Date: 13 February 2025
Ref: WU34534
To: BOCMA
By eWULA: Department of Water and Sanitation

this correspondence is to confirm that Confluent Environmental conducted the Water Use License Application for Familie Roux Eeindomme (Pty) Ltd for the proposed housing development on Portion 91 of Farm Matjes Fontein 304, Keurboomstrand.

COMMENTS AND RESPONSE REPORT

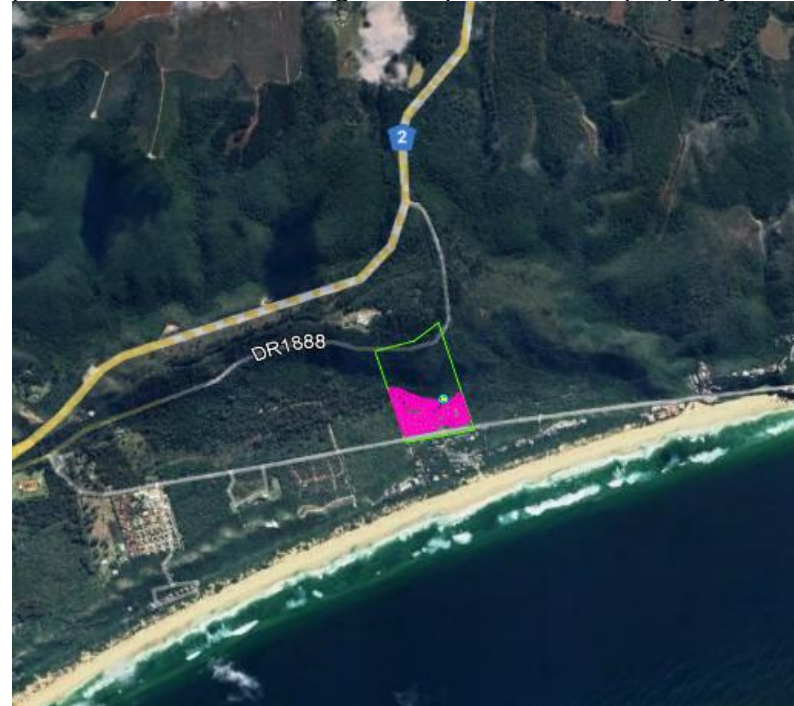
The below listed project bears reference. May I request that you provide me with a locality plan in which the N2 has been indicated in relation to the proposed project please.

Please see below map, where the green line is the outline of Farm 91/304 and the pink indicates the housing development on the property:

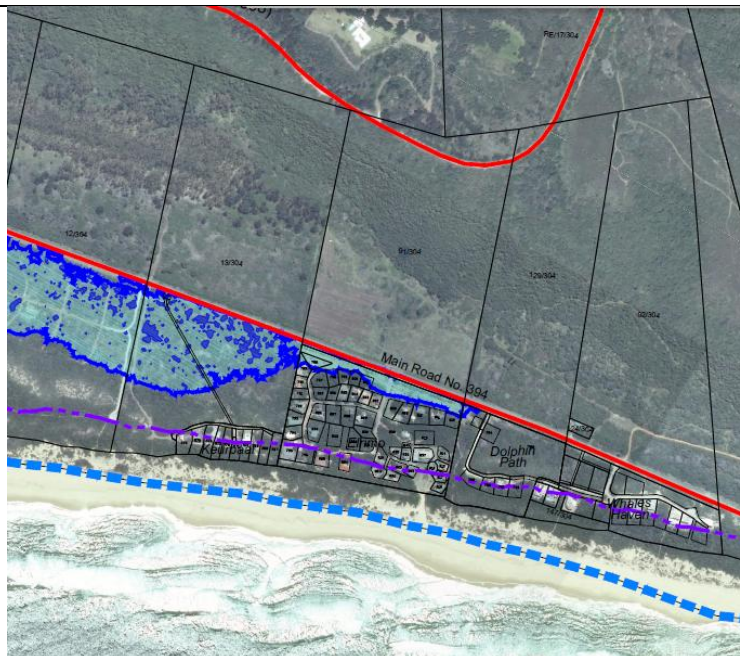
COMMENT 6.1: The WULA Report has failed to identify and assess the full scope of impacts associated with the water uses entailed in the proposed development by failing to take account of the potentially significant flooding risks associated with the Property (which will be exacerbated by the proposed development).

RESPONSE: It is worth noting that Cullinan's point states that the property potentially has a significant flooding risk which would be exacerbated by the development. But no flooding risk has been identified in KELASP planning document for Keurbooms which presents the 1:100 year floodline across the road from the property in a very small area (see clip below from Pg 31 in the report), and recommends certain areas be excluded from development because of their location in relation to floodlines. The report does not exclude Portion 91 and actually identifies the property as having at least 1.6 ha of developable area with development potential for at least 19 units. In contrast, Milkwood Glen (represented by Cullinan, and across the road) has approximately 49 residential erven, some of which are inside the 1:100 yr floodline AND beyond the 100m coastal setback line, covering an area of 6.2 ha, which are very similar parameters to that proposed at Portion 91/304.

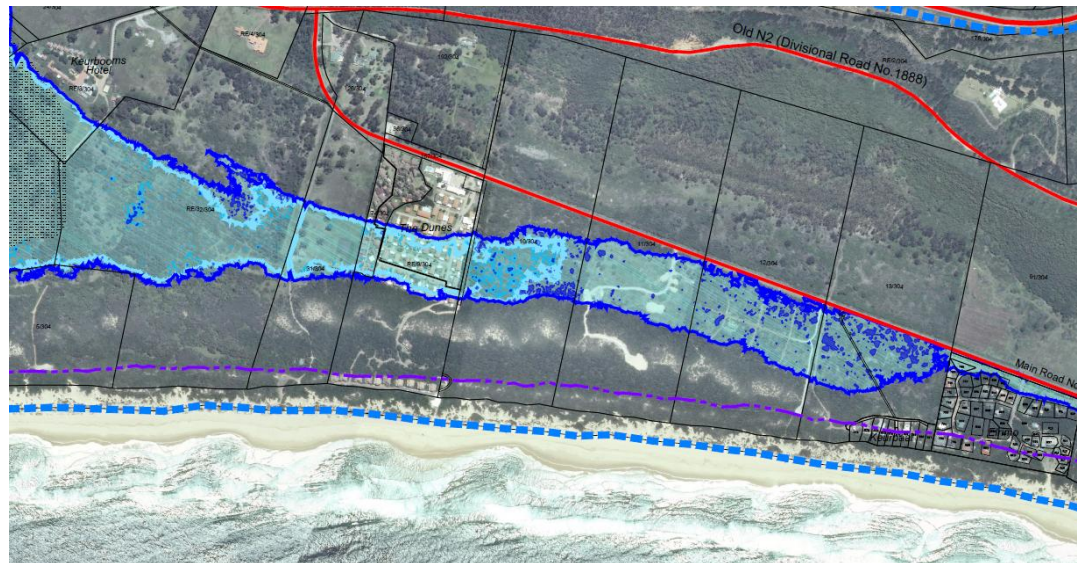
COMMENTS 17. The need to preserve the Keurbooms valley on the north side of Keurbooms Road as a flood plain was confirmed during November 2007 when the Bitou area experienced high rainfall, resulting in the Keurbooms River bursting its banks and flooding surrounding areas (including resorts and individual houses). During that time, Keurbooms Road was impassable, and the Dunes resort was 1.5 metres under water. From here, water spilled into vacant ground on both sides of Keurbooms Road including the entire Keurbooms valley to the south of the road. The flood attenuation role of this property has also been evident during significant storm events (such as those experienced as recently as May 2023).

RESPONSE: Noted that the 2007 was a serious event and a good benchmark of the impacts of serious flooding in the area. The Dunes resort (mentioned in the comment) is located well within the mapped 100 year floodline and close to the Tshokwane wetlands (image below from the KELASP). It is a poorly located development and a simple analysis of the floodlines highlights the risk that materialised. However, portion 91/304 is mapped above the 1:100 year floodline towards the eastern-most extent of the floodline representing a much reduced risk. The flood attenuation role of the property is not going to be diminished because the engineering plan has incorporated a number of SuDS measures including permeable paving on main roads, open pavers (grass blocks on secondary roads, 3 stormwater attenuation ponds, and an armorflex lined swale to intercept runoff from the slope (Aquatic specialist, Confluent).

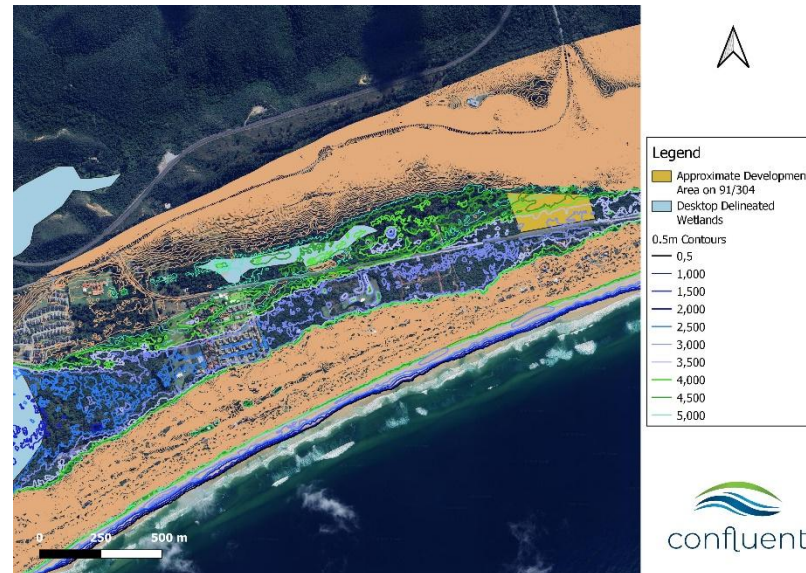
The proposed development is situated some 5.8km along the shoreline from the main part of the Keurbooms Estuary mouth. It is therefore initially surprising that part of the area is included in the Estuarine Functional Zone (EFZ) of the Keurbooms Estuary. However, a more detailed examination of the topography to the east of the Keurbooms Estuary indicates that there are low-lying areas on the inland side of the coastal dunes (Figure 1). Although quite detailed 2m contour maps were provided, they do not extend all the way to the estuary and it is difficult to definitively conclude that the development site is directly hydraulically connected to the estuary during high floods. However, all the evidence points to the fact that it is connected and will form an inundated backwater area when the estuary is subjected to flooding. This is supported by the cross-section data (approximately north-south through the proposed development property) that indicates that most of the area to be developed is below 5m above mean sea level.

RESPONSE: (provided by J. Dabrowski) 0.5m contours were sourced for the coastline from DEA&DP and a map showing the contours of the site along the entire coastline from Keurbooms estuary to the project area was compiled and added to the aquatic specialist report (see below, and Fig 17 in the

report). The furthest extent of known flooding during the very serious 2007 floods was the Dunes development (indicated in Fig 17 of the aquatic report). That development is 2.5m amsl while everything east of that is at 3m or higher. While extreme floodwaters from the Keurbooms could theoretically push further east, the Keurboomstrand road acts as a barrier to waters from moving north. What is also clear from the below figure is that there is no way that development on Portion 91/304 could remove flood storage area from the floodplain that would negatively impact on flooding for others in the floodplain. As this property is at the end of the floodplain, it would receive floodwaters last, and is therefore more susceptible to other developments removing flood storage area. Again, the 1:100 year floodline is located south of the road and no part of the development proposed is within the floodline.
